**HYATT PLACE  
2006 POLARIS PARKWAY, COLUMBUS, OH  
CITY OF COLUMBUS SWDM  
TYPE III VARIANCE APPLICATION**

JULY 2019

PREPARED BY:  
**THE MANNIK & SMITH GROUP, INC.**  
1160 DUBLIN ROAD, SUITE 100  
COLUMBUS, OHIO 43215

**Re: Hyatt Place SWDM Variance**

**PRELIMINARY LANDSCAPING PLAN**  
**L100**

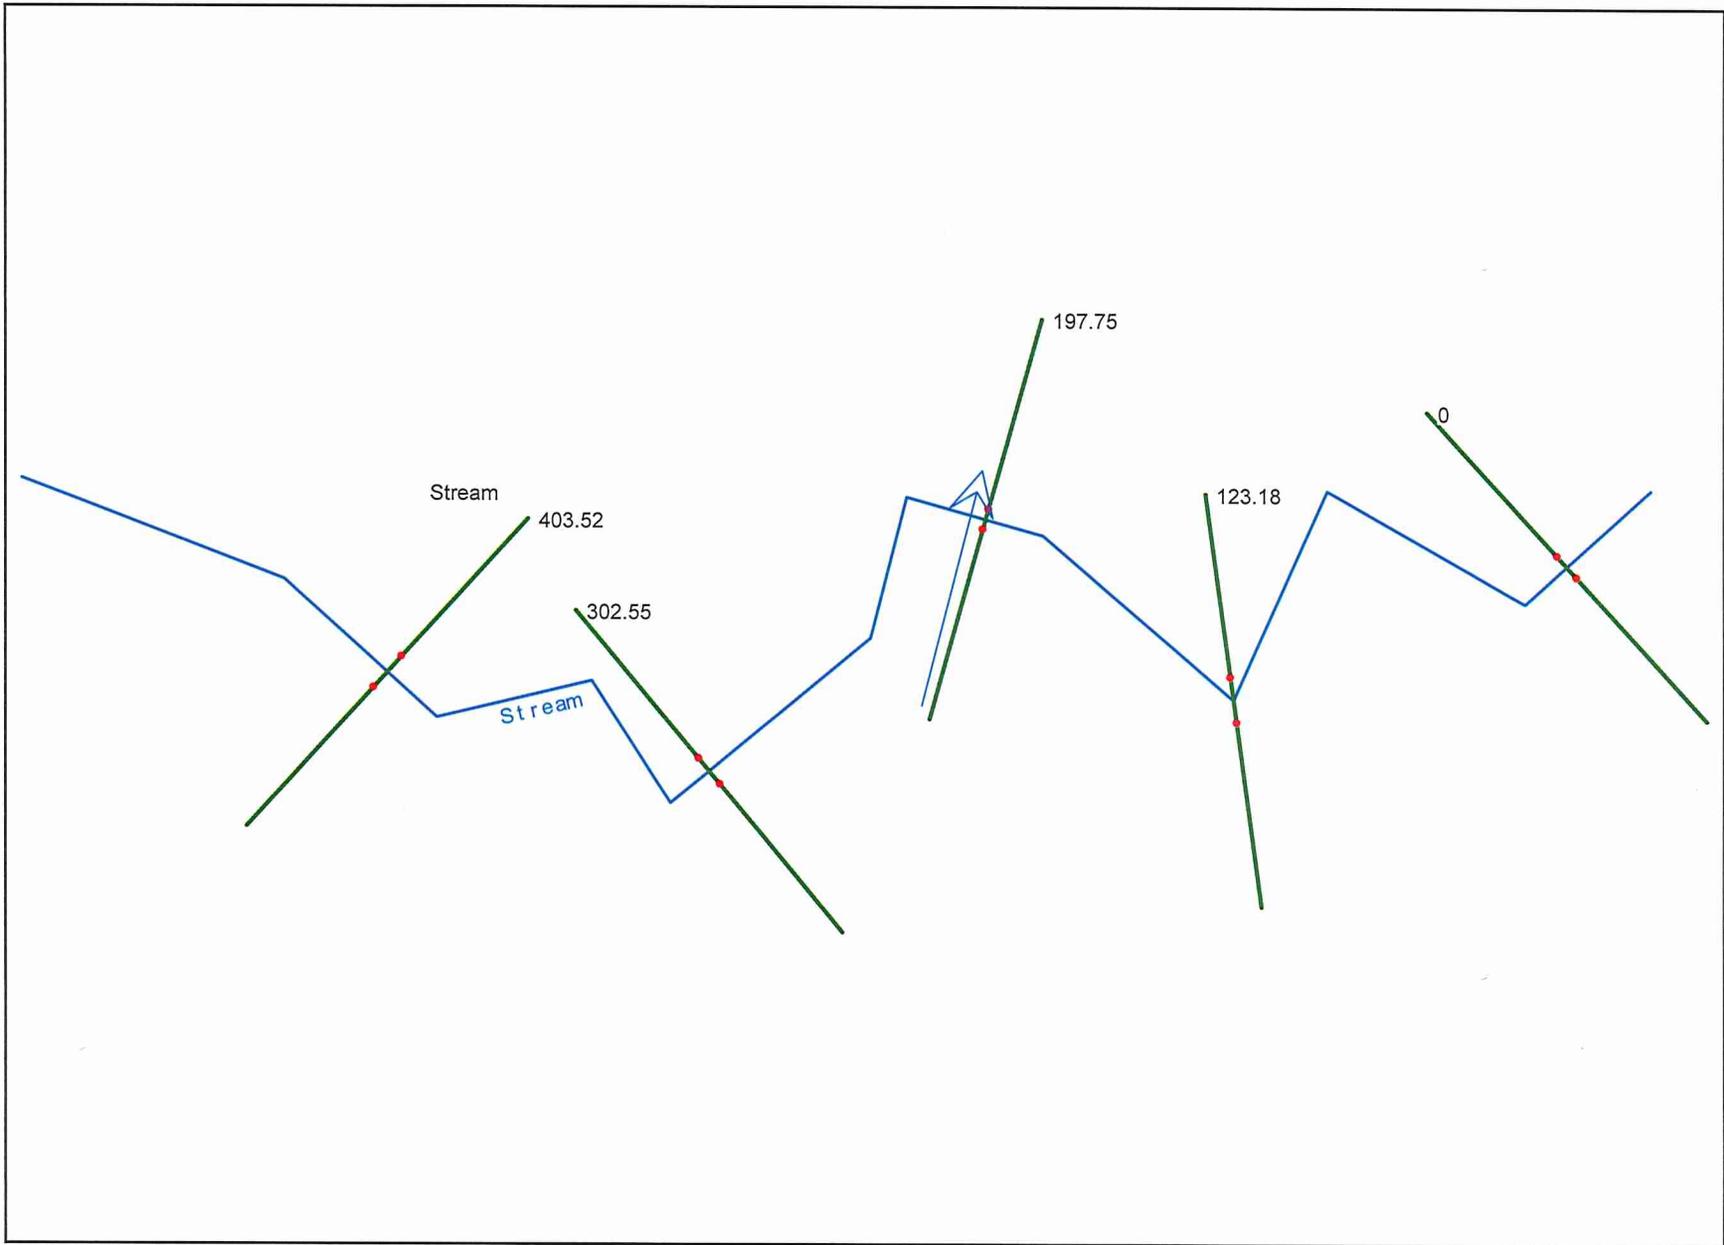
Additionally, we noticed that in the landscaping plans (L100), the restaurant building is labeled “building area will be seeded.” Because the restaurant area is marked as “will be seeded,” and the hotel building is not, the plan raises important questions about the construction of the restaurant. Does this mean the restaurant will not be constructed initially? If so, when it will be constructed? Is construction of the restaurant certain? We ask because delaying or cancelling the construction of the restaurant would render the extensive parking lot useless or, at the very least, irresponsible and wasteful. If this is indeed the case, even 208 parking spaces would be excessive; the total could be greatly reduced, once again lowering overall construction costs.

According to Hyatt Place “L102” in Layout 1, this would be an additional 8 trees. This number can and should change depending upon the final construction plan and resulting number of trees removed. Additionally, after examining all of the submitted documents, we do not see any direct reference to grass, shrub and tree species that will be planted, only a general reference to individual “T-DEC,” “T-EVG,” “T-ORN,” “S-EVG,” “S-DEC,” etc. We assume these labels correspond to deciduous, evergreen, and ornamental, despite the lack of a visible legend. However, this does not inform us of the plant species, making it impossible to determine whether the landscape will foster healthy plant growth of native species and contribute to livable space for Ohio’s native species of flora and fauna or even whether the species will be invasive species, which could have lasting, devastating effects on nearby wildlife. Moreover, there is only one illustration for planned plant landscaping, “L100,” and it corresponds to only *one* of the possible construction plans, Exhibit 4, the exhibit with the excessive 226 parking spaces. We would like to see alternative arrangements with fewer parking spaces and more specific information about the landscaping plans, including the names of plant species. We request that this information be shared before the variance is accepted, as it is crucial to ascertaining the quality and sustainability of the development and its impacts on the surrounding and supplanted environment.
